URBAN DESIGN COMMITTEE

URBAN DESIGN COMMITTEE STAFF REPORT

APPLICATION NUMBER	Urban Design Record #23049
APPLICATION TYPE	Neighborhood Design Standards Appeal
ADDRESS/LOCATION	2200 R Street
HEARING DATE	June 06, 2023
ADDITIONAL MEETINGS	-
APPLICANT	Jesse Benedict, jesse.benedict@gmail.com
STAFF CONTACT	Arvind Gopalakrishnan, 402-441-6361, agopalakrishnan@lincoln.ne.gov

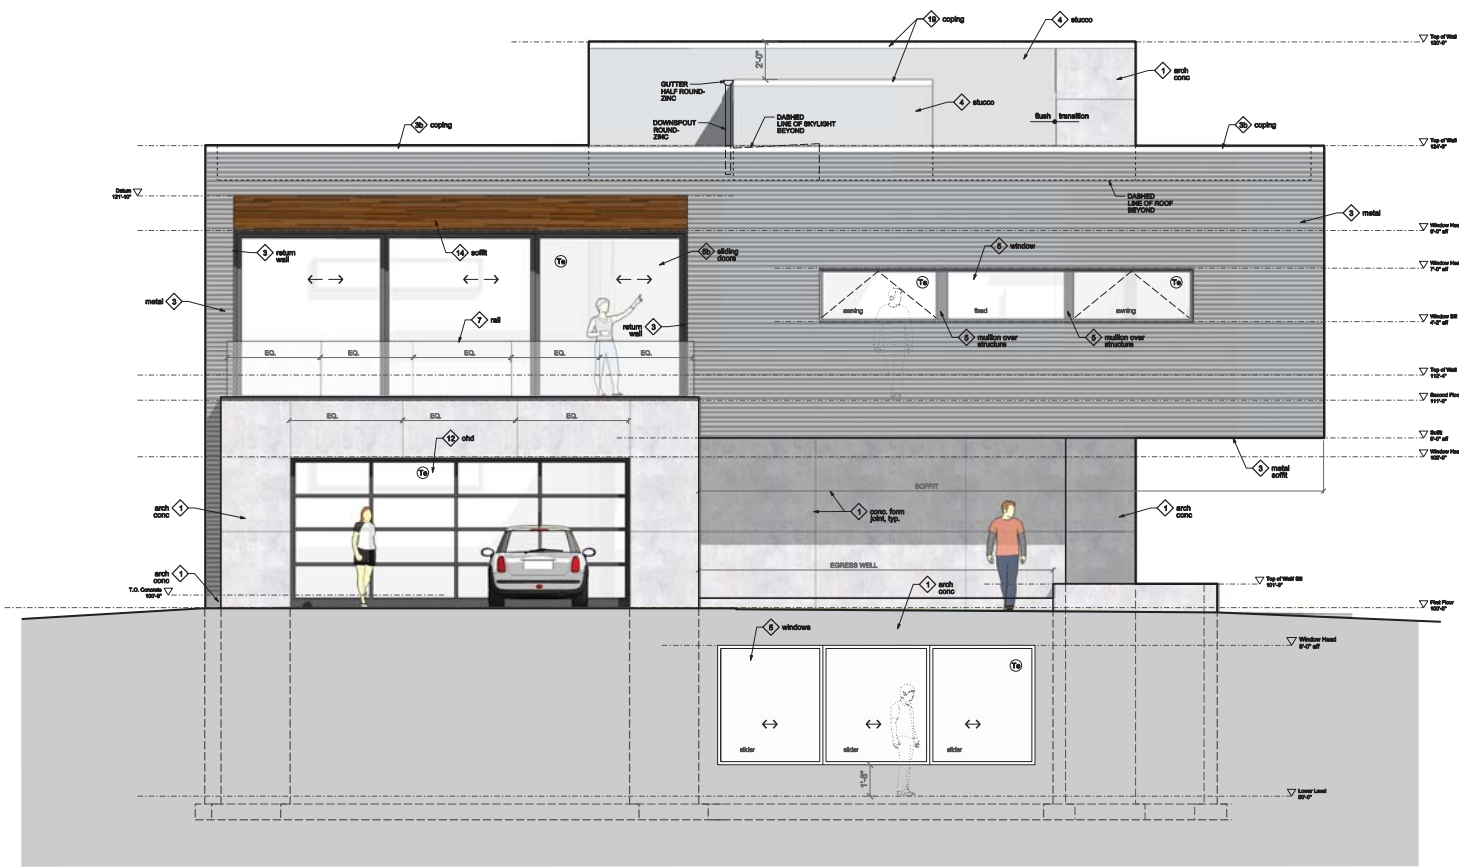
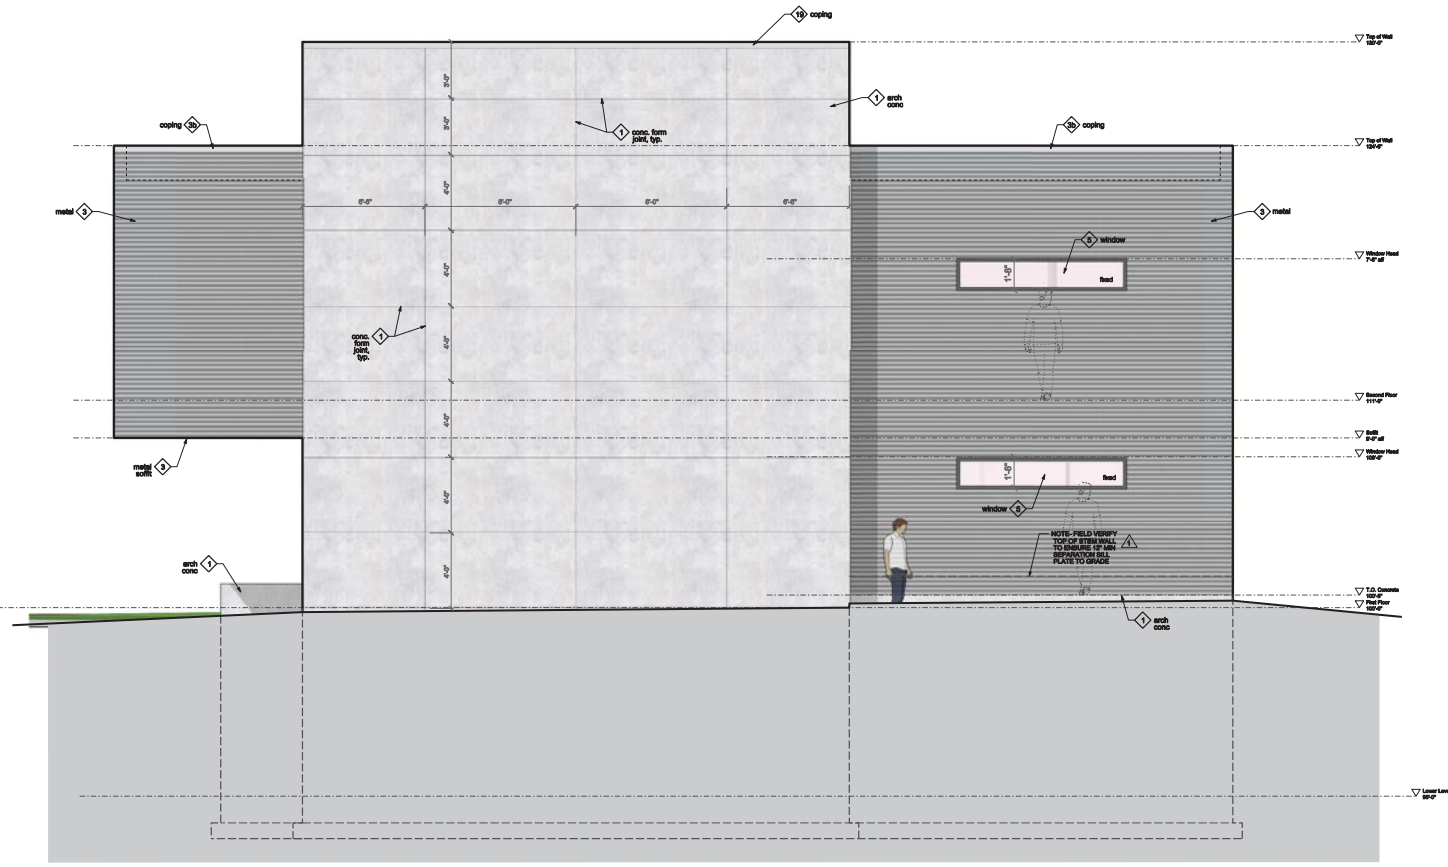
Generally, the design fits well in its surroundings, and is compliant with the Neighborhood Design Standards, except for one inconsistency. The design is expected to have a minimum of two openings per story oriented to the street. The west façade facing N 22nd Street only has one garage door and no other windows or openings on the first floor.

In general, the plans are in conformance with the design standards. However, the windows and opening requirements for the west façade of the building are not met with the current design.

Staff Note: As the design does not meet the standards, the Planning Director has denied a waiver for any deviations from the standards. To meet the spirit and intent of the design standards, we recommended adding one window of common size on the west façade. However, the applicant argued that it would affect the current design of the wall on the inside significantly. The applicant and their architect would thus like to seek the Urban Design Committee's advice and officially appeal the Planning Director's decision denying the waiver.

Initial Concept with the sidewalk café attached to the restaurant. (Received from the applicant)

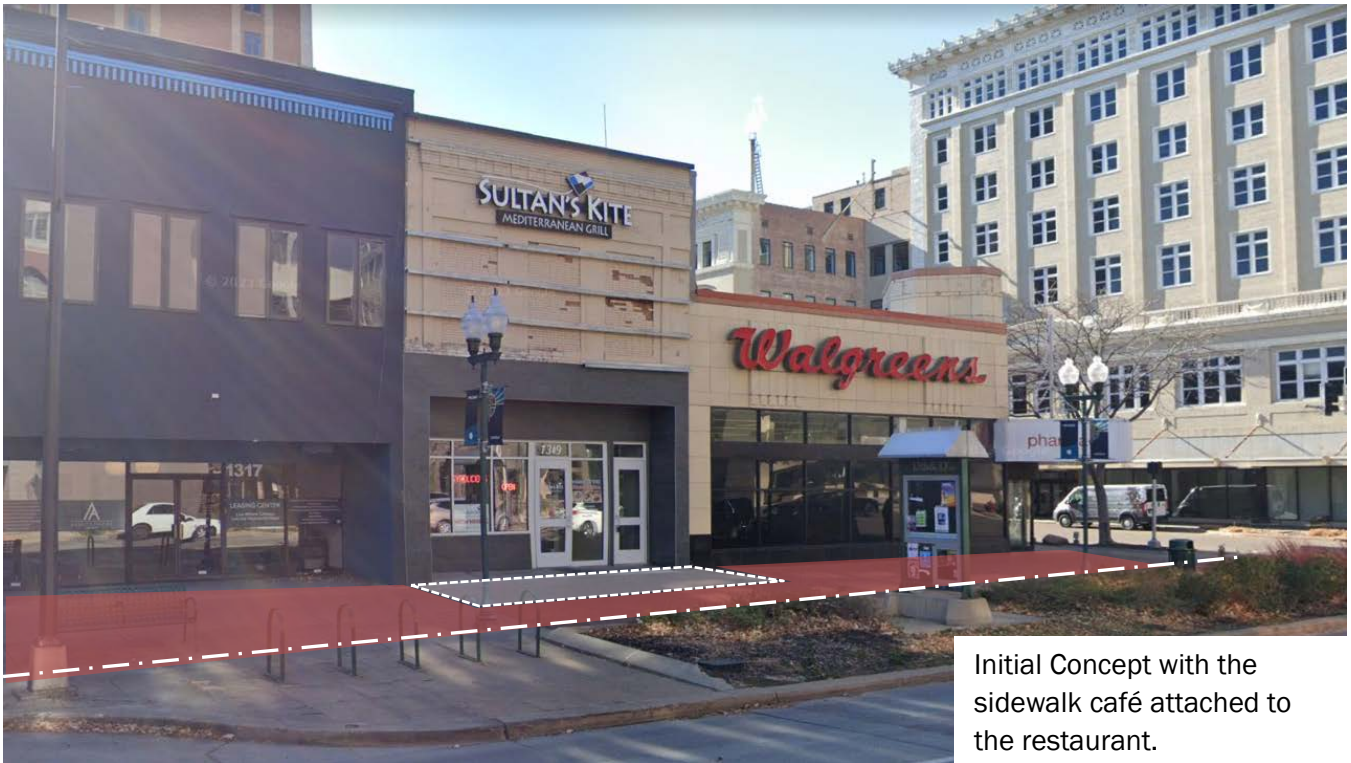
Compatibility per Staff Analysis: Questionable

The sidewalk space available outside of the building is approximately 18' wide. Installing a 10' wide fencing would leave around 8' of passageway for pedestrian movement spanning the length of the building fronting O Street. Currently there is a street-light on one of the corners of the proposed side walk café, and it is situated in the 8' passageway (space between the edge of the proposed fencing and landscaped verge). This edge of the sidewalk café railing might interfere with the pedestrian and bike traffic and make part of the passageway congested. The hand-drawing below was included by the applicant in the application package, and the two following images are a diagrammatic representation of the same.

After careful consideration, the staff recommends that the sidewalk café be closer the planting bed, away from the property, leaving 8' of pedestrian passageway between the restaurant and the outdoor café.

JAKE'S FURNITURE PLAN

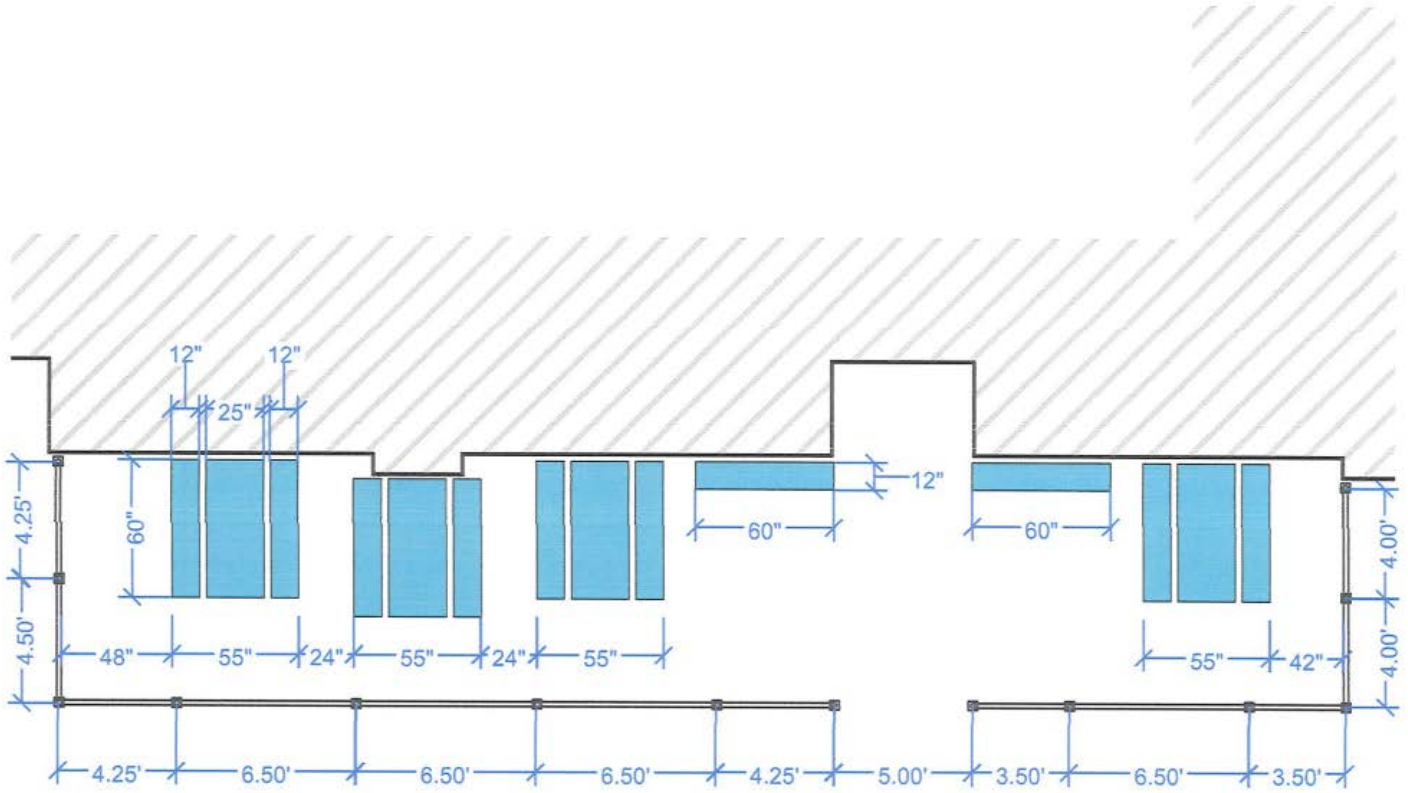
Staff recommends the following arrangement of bike racks:
 4 racks in front of Jake's and 3 in front of Jimmy John's. The racks should be placed 2' from the curb/planting bed.

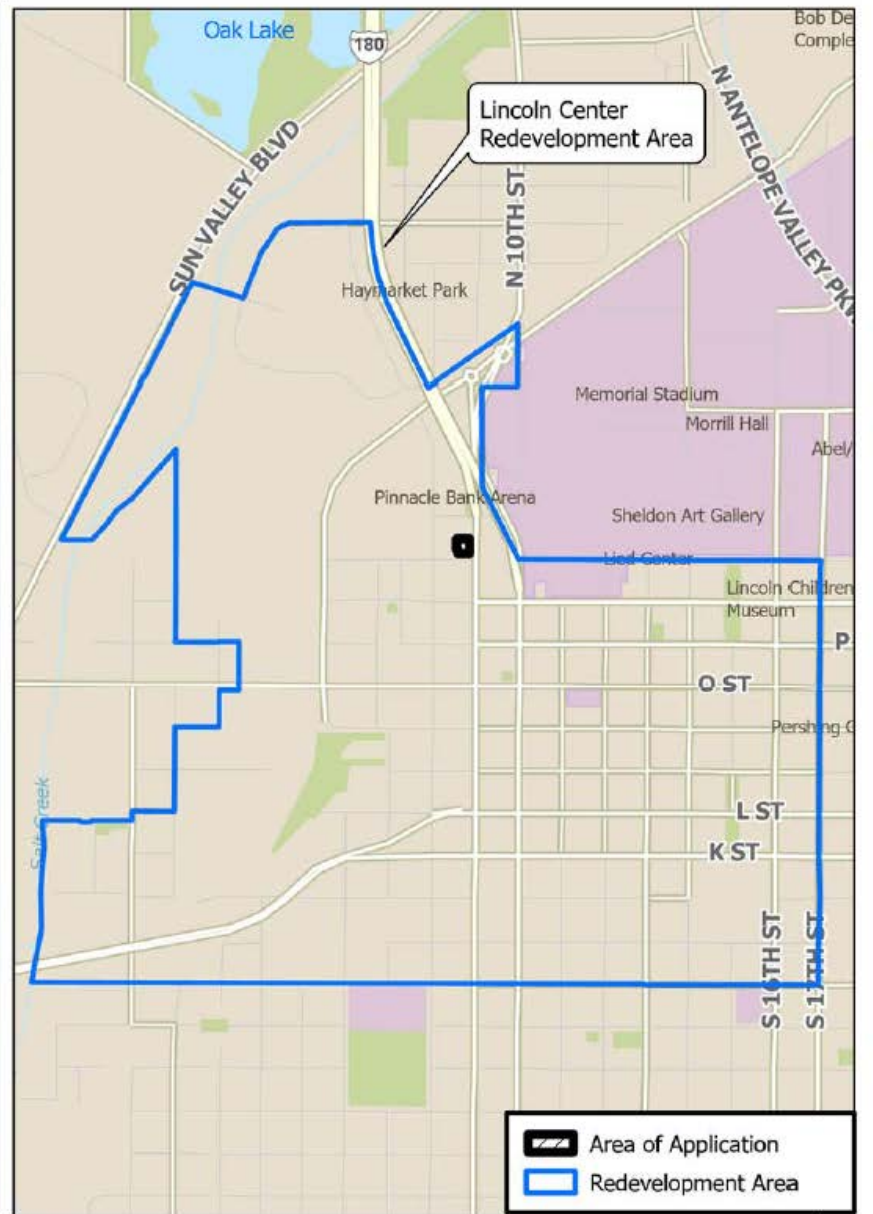
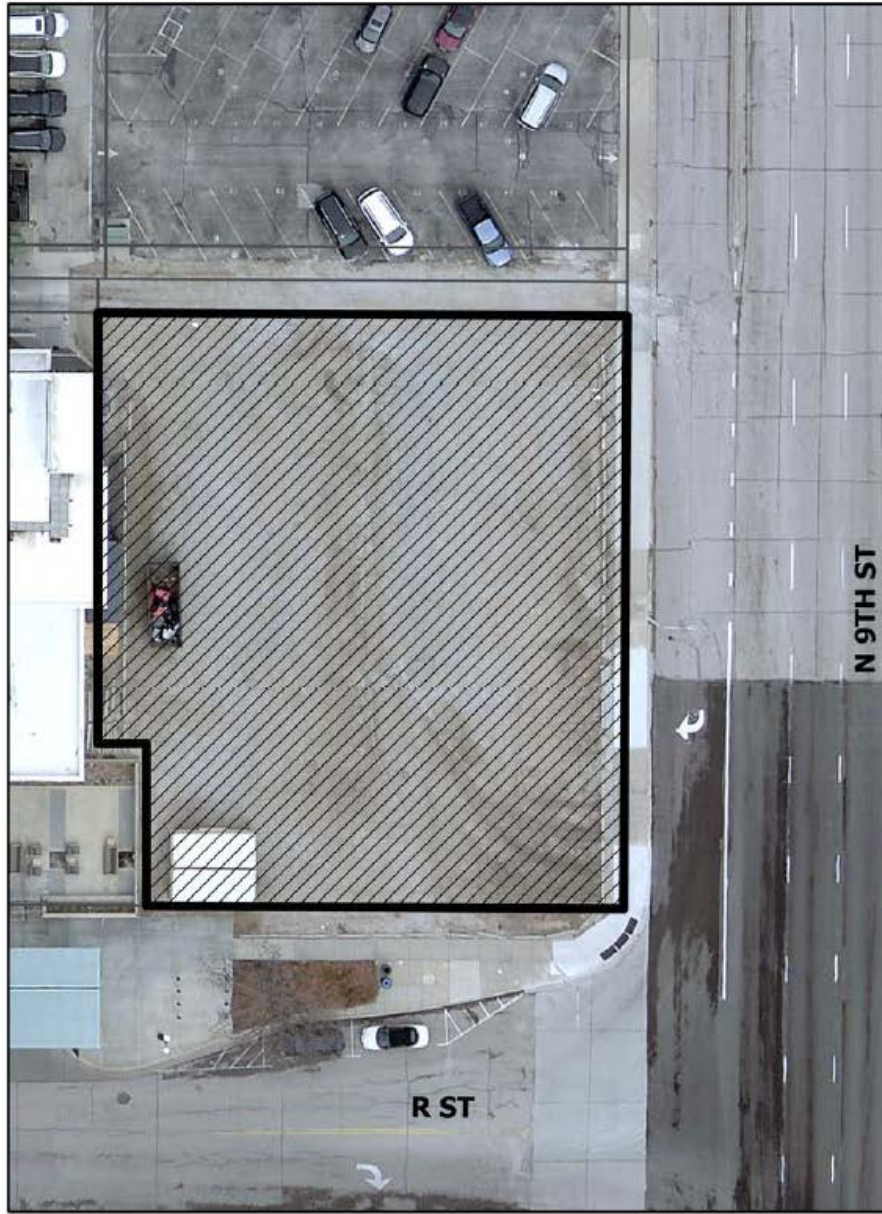
As can be seen in the attached renderings, the original proposal included a freestanding canopy south of the building that would complement the existing canopy in front of the adjacent Courtyard by Marriott. What is now being shown is an enlarged canopy extending out from the building's south façade. The canopy would consist of white fascia and soffit, with a faux framing recess above the lobby entry point. This recess would be lit to further highlight and brighten up the entry.

The Urban Design Committee is being asked to weigh in on these proposed canopy modifications.

The materiality of the proposed canopy should be presented by the applicant and discussed by the Committee, but ultimately this modification does not appear to be in conflict with any of the Downtown Design Standards.
